## Addendum #2 Request for Bids (RFB) 2020-03 Isle of Palms Marina Rehabilitation August 28, 2020

This addendum is intended to provide further clarification to the Bid Documents for this project, dated July 10, 2020. Specifically, this addendum intends to address the bidder questions received by the City. Also, note a revised bid form is provided along with several attachments. The bid due date is also hereby extended to September 11, 2020. Bids shall be due by 11am local time on this date.

#### PIPING LONGITUDINAL RESTRAINT DETAIL

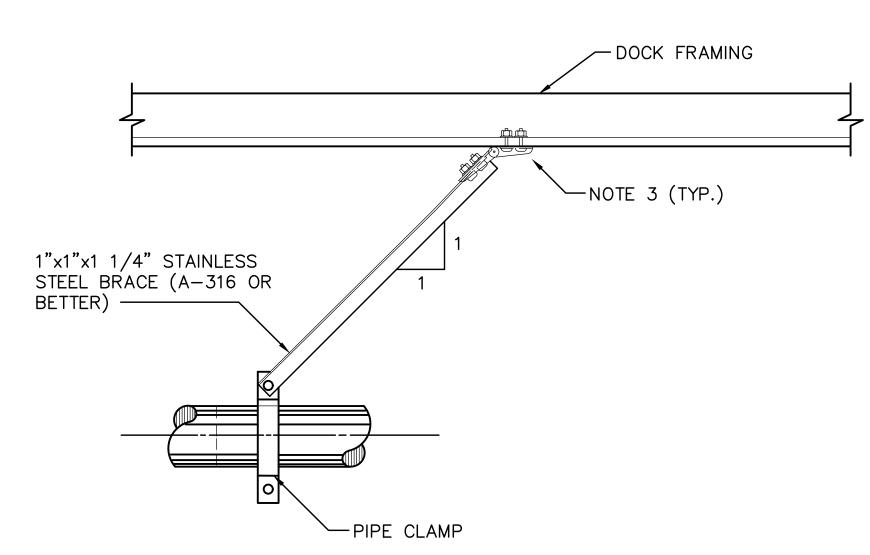
- A: Yes. Provide as manufactured by Petroleum Containment, Inc.
- Q: Omegaflex warranty installation recommends the piping be evenly supported at a minimum of 6' intervals using Omegaflex 2" vibration resistant cushion clamps/ or equal.

FD3 detail shows a "piping longitudinal restraint detail" that does not meet Omegaflex recommendation for a warranty installation Can the "piping longitudinal restraint be eliminated from the installation requirements?

- A: Yes.
- Q: FD3 Existing transition sump detail
  Can the specified water tight H20-rated diamond plate cover be replaced by a composite cover meeting the same ratings?
- A: The transition sump is existing, and a new lid is not required.
